MARATHON COUNTY PUBLIC LIBRARY
ADDITION AND REMODELING
WAUSAU, WISCONSIN

HSR L920154

JUNE 1993

HSR ASSOCIATES, INC.
Architecture/Engineering
La Crosse & Madison, Wisconsin

ELECTRICAL SITE PLAN
1" = 20'-0"

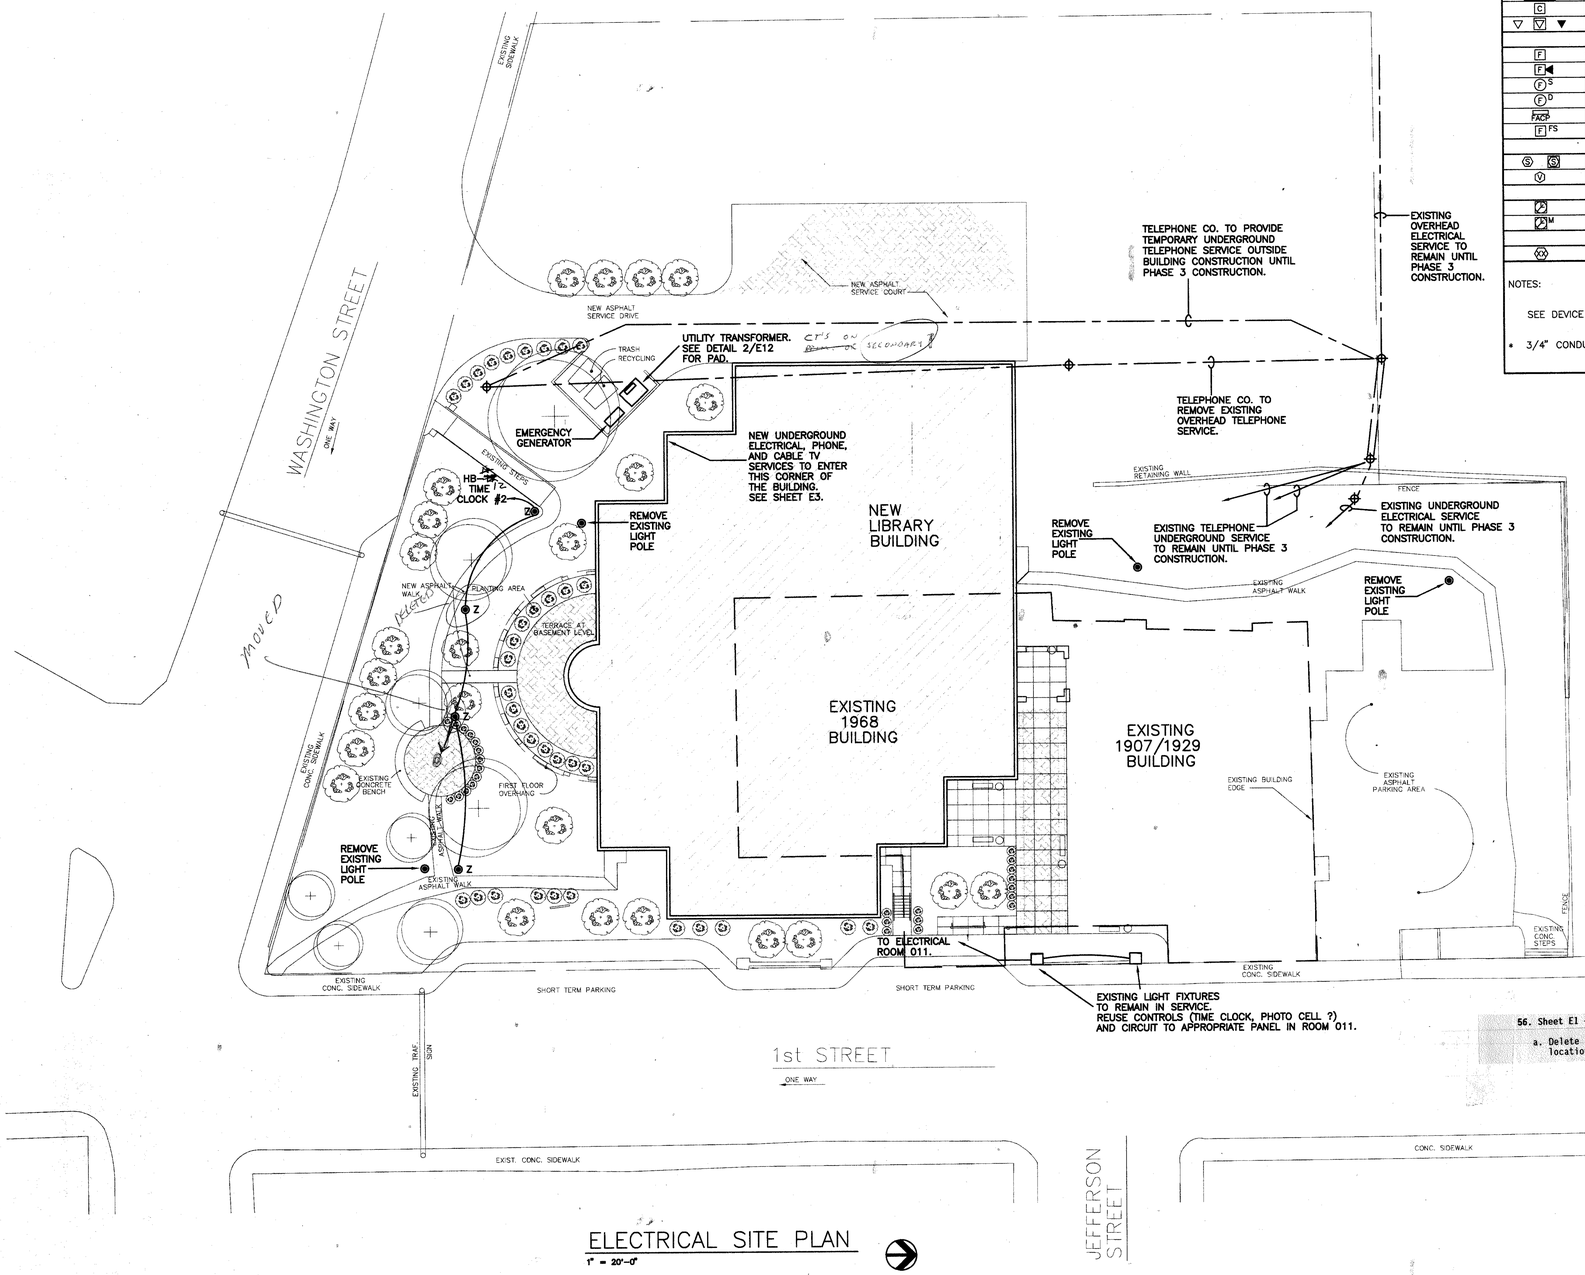
56. Sheet E1 – ELECTRICAL SITE PLAN.

a. Delete one of the Type "Z" fixtures. See the enclosed Sheet E14 for the location of the remaining three.

BASEMENT LIGHTING PLAN

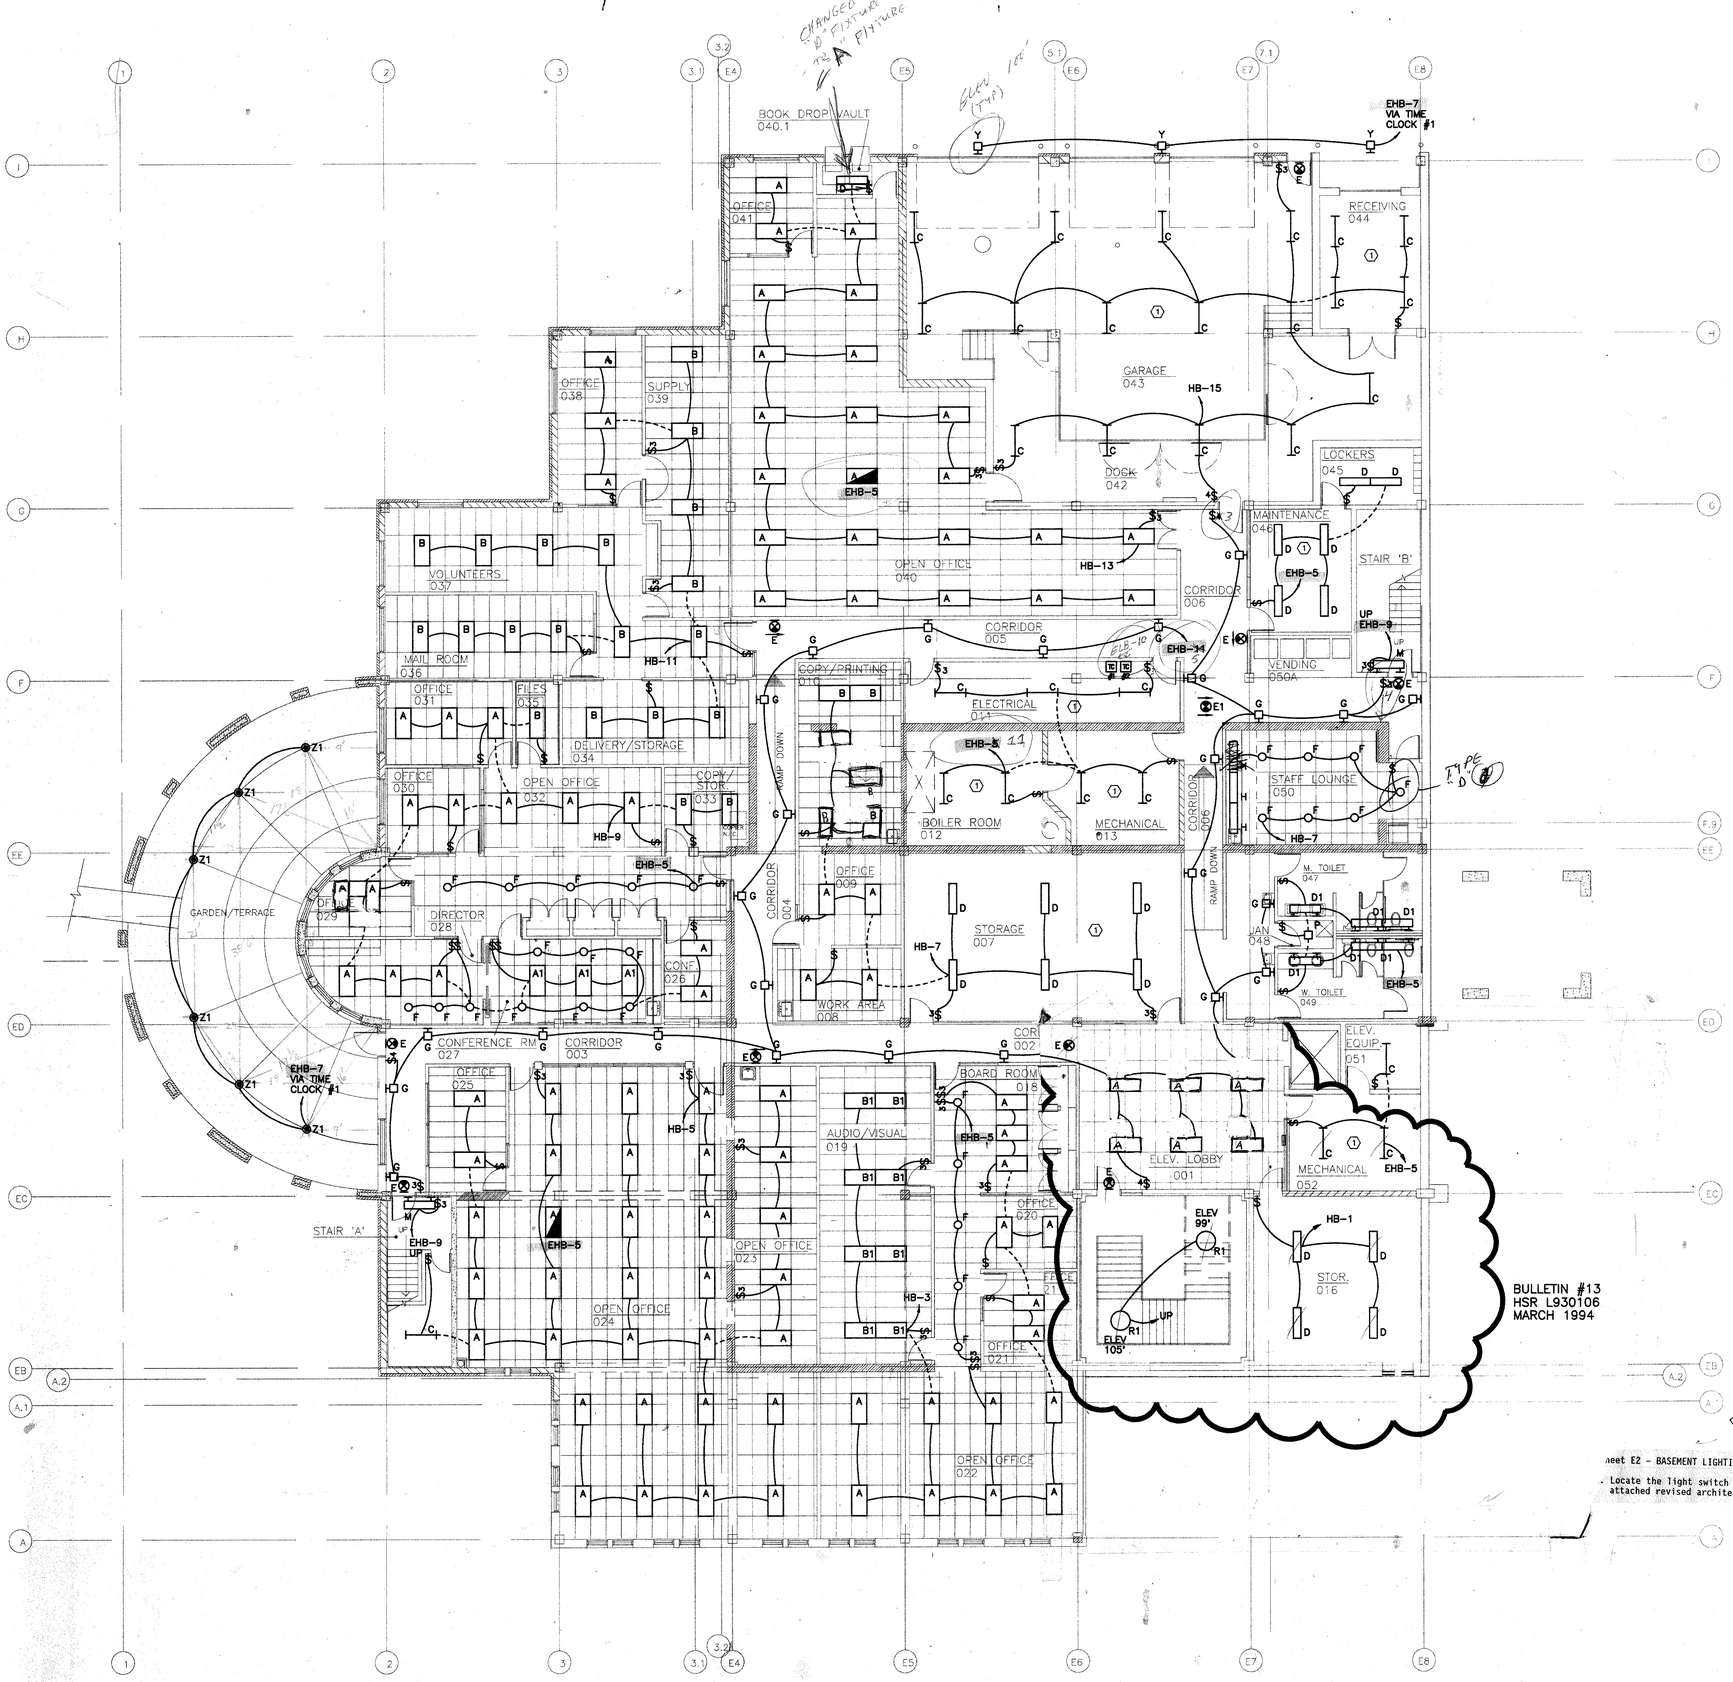
...heet E2 - BASEMENT LIGHTING PLAN.

. Locate the light switch in Room 040.1 to the new door location. See the attached revised architectural drawing.

BASEMENT POWER PLAN

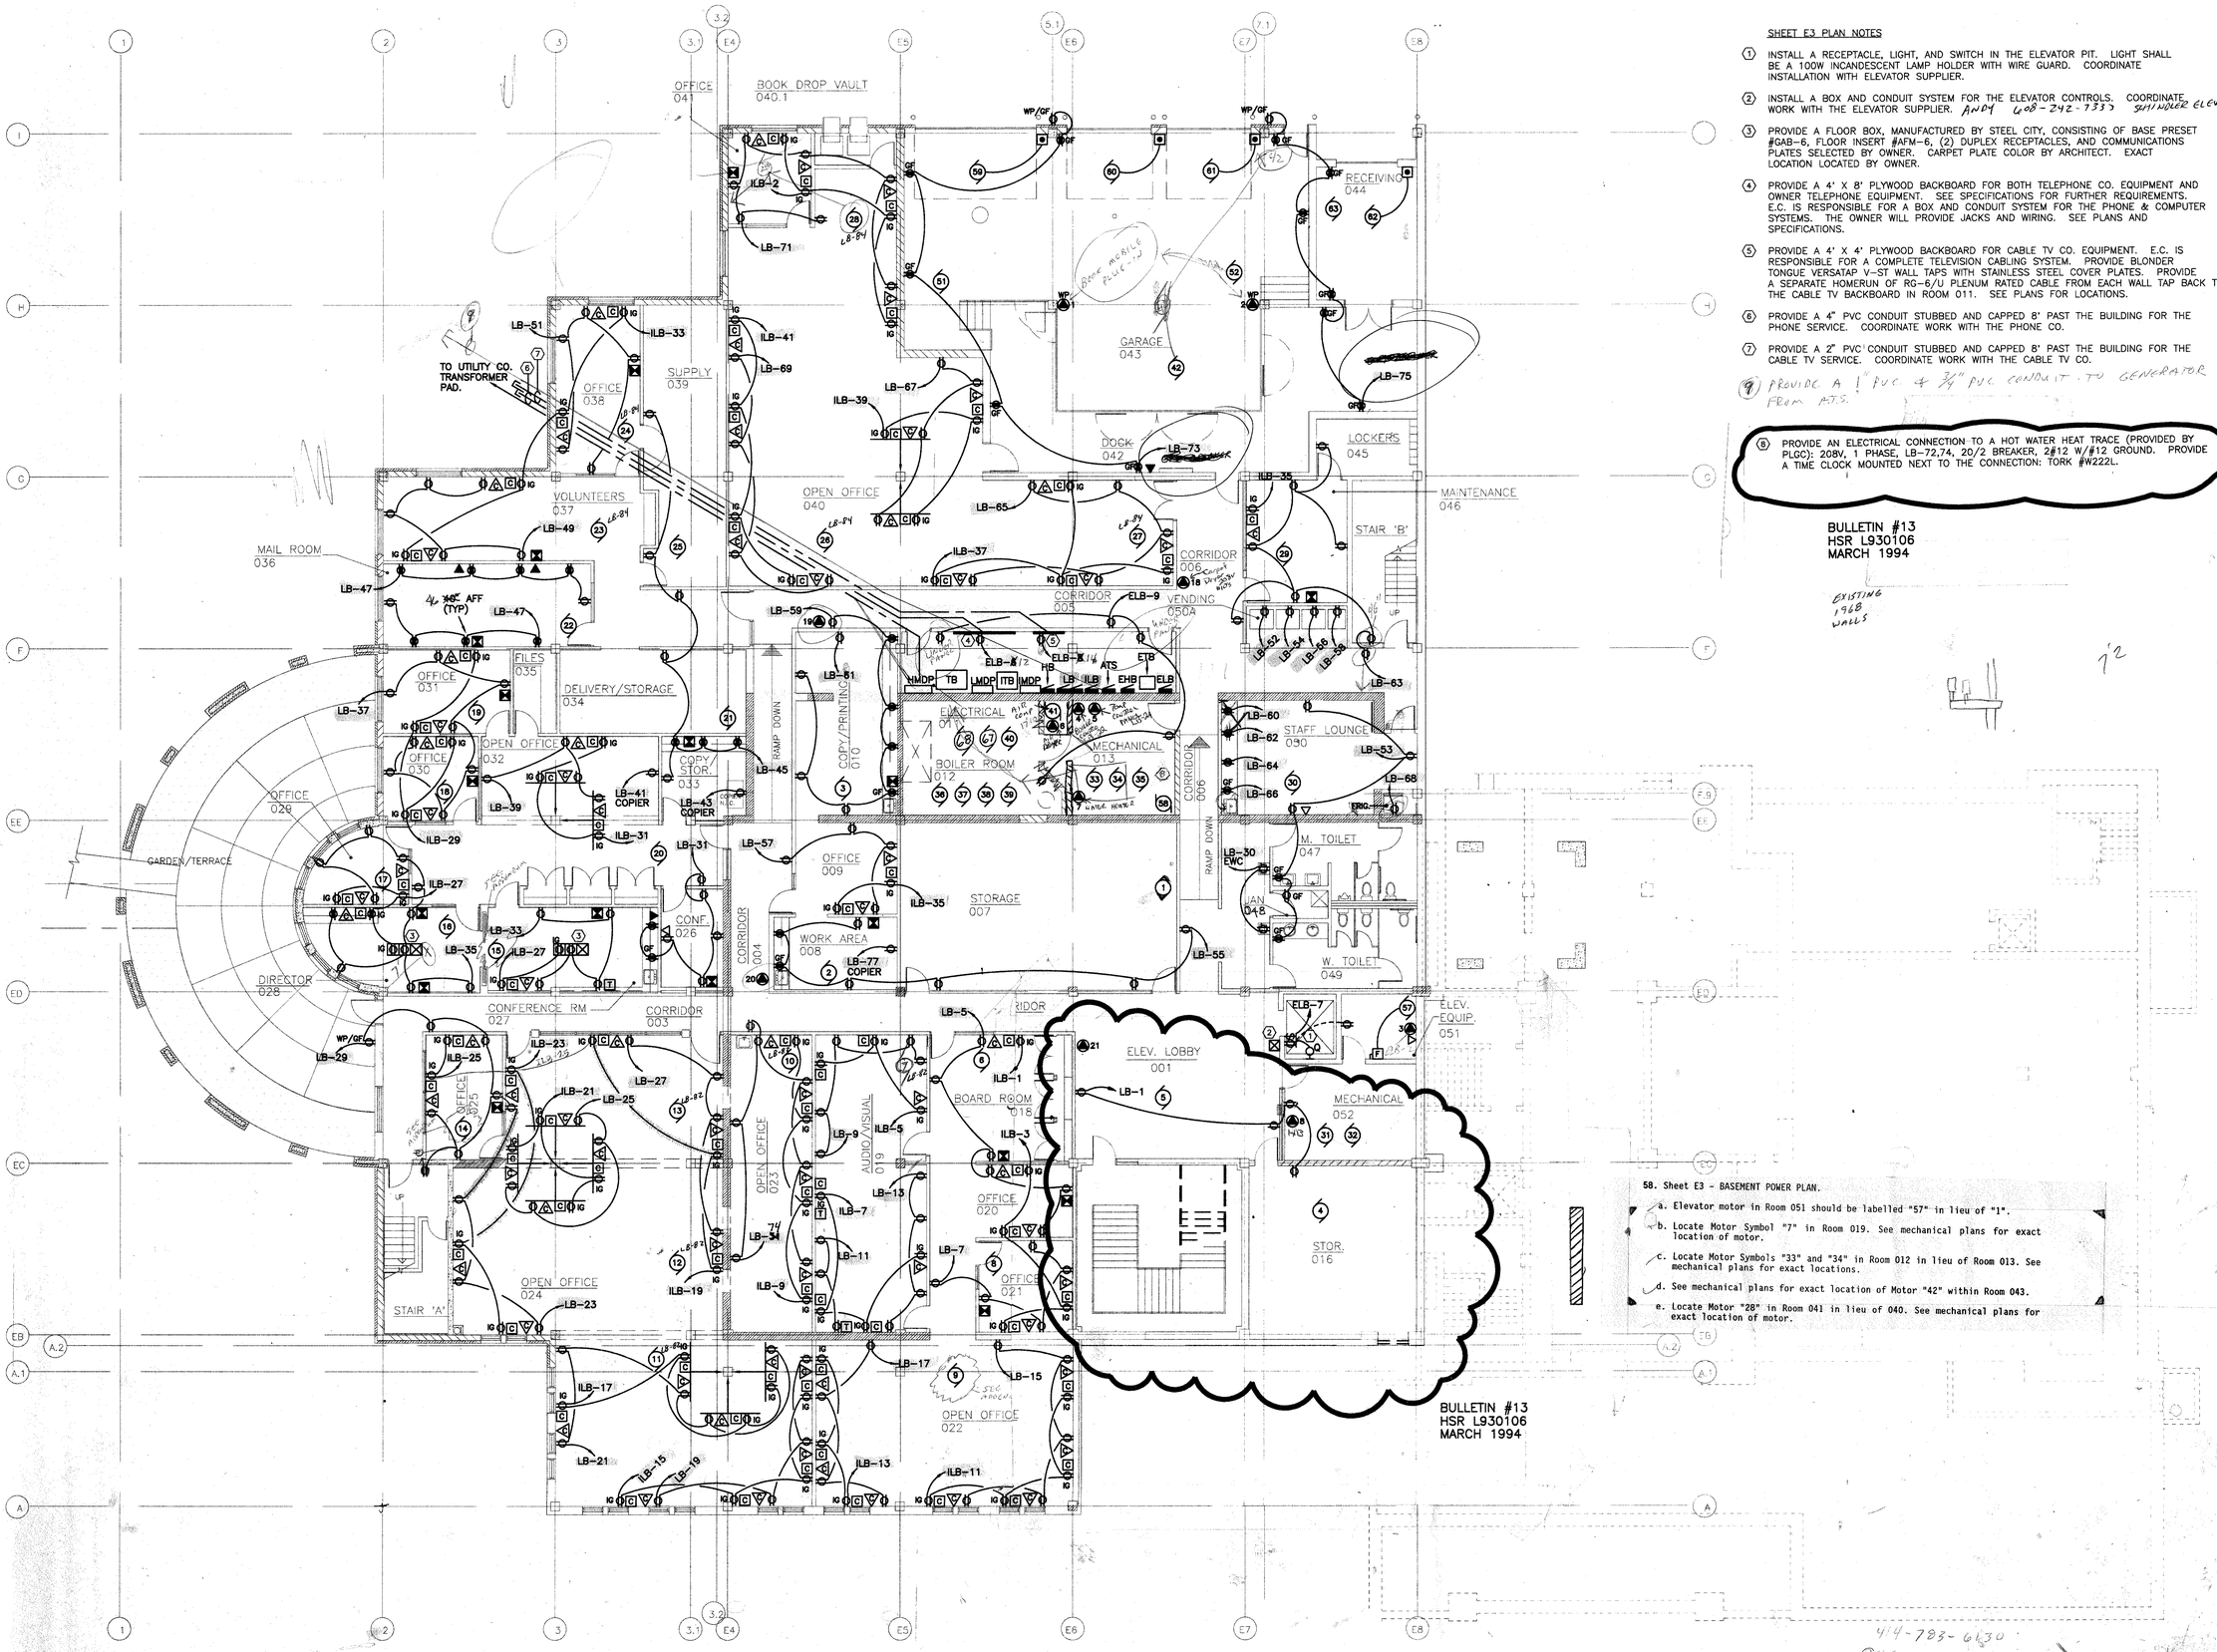
58. Sheet E3 - BASEMENT POWER PLAN.
   a. Elevator motor in Room 051 should be labelled "57" in lieu of "1".
   b. Locate Motor Symbol "7" in Room 019. See mechanical plans for exact location of motor.
   c. Locate Motor Symbols "33" and "34" in Room 012 in lieu of Room 013. See mechanical plans for exact locations.
   d. See mechanical plans for exact location of Motor "42" within Room 043.
   e. Locate Motor "28" in Room 041 in lieu of 040. See mechanical plans for exact location of motor.
